# United States Patent and Trademark Office

APPLICATION NO.		FILING DATE	FIRST NAMED INVENTOR	ATTORNEY DOCKET NO.	CONFIRMATION NO.
10/696,958	96,958 10/30/2003		James Patrick Clinch	140/40303A	8485
279	7590	12/16/2005		EXAMINER	
	•	NELL, GIANGIOR	MITCHELL, KATHERINE W		
BLACKST 105 WEST		IARR, LTD. STREET	ART UNIT	PAPER NUMBER	
SUITE 360	0		3677		
CHICAGO	, IL 606	03	DATE MAILED: 12/16/2005

### **DETAILED ACTION**

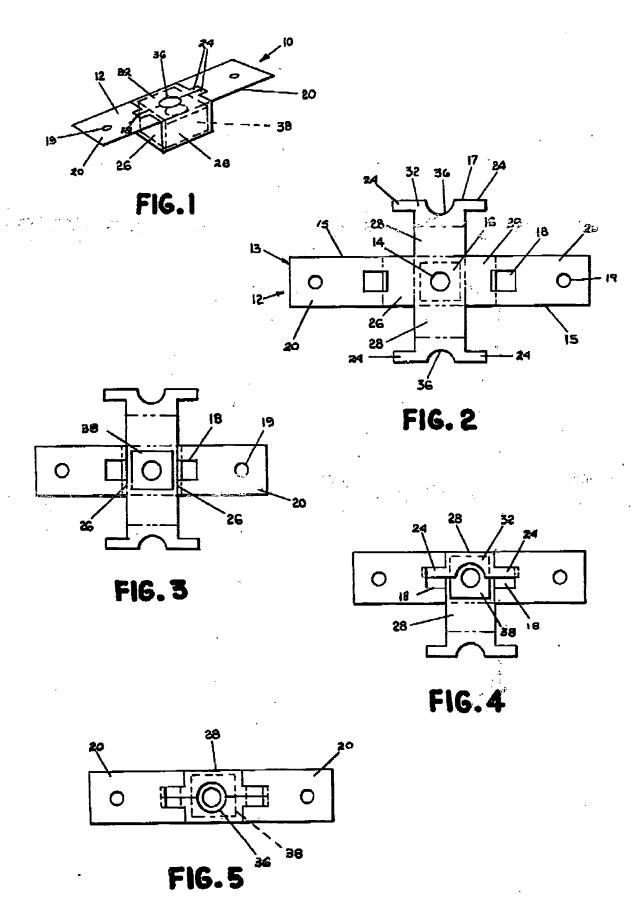
Re claims 1- 3, 6-9, 21,23, 27-32, 34-39, and 43-46: Anderson teaches a cage member (Fig 1, see 12) engageable with a nut 38 having a threaded aperture (col 2 line 57), said cage member capable of encaging the nut (Fig 1) and having an aperture to

allow access to the threaded nut (Fig 1), said cage body having a base portion 16 and 1<sup>st</sup> and 2<sup>nd</sup> arms (28) extending from said base, and a seam (where 17 joins - Figs 1, 2 and 4) defined between 1<sup>st</sup> and 2<sup>nd</sup> arms (see below), at least one of said arm portions having at least one protrusion (tab 24 is considered a half protrusion, and protrudes from arm, two together are considered to form a whole protrusion, and there is a seam therebetween the formed protrusion, see Fig.1) capable of being welded to a mating surface, said seam capable of being provided proximate to a mating surface. Clearly the seam is capable of being near an (unclaimed) mating surface, and the protrusion is capable of being welded to a mating surface. The seam is weldable - both parts are metal. The nut is capable of moving in at least one dimension relative to the base when the nut is encaged. The cage forms a seam (Fig 1 and 5) which is located proximate the mating surface, The fist and 2<sup>nd</sup> arms portions define lower portions of the cage member Fig 1 - orientation is arbitrary). And note that the protrusions 24 protrude from the lower surface (section 32 is shown in Fig 1 as covering 20). There is an aperture configured to allow access to the threaded aperture when the nut is encaged by the cage. The cage and nut members are separately formed and non-integral.
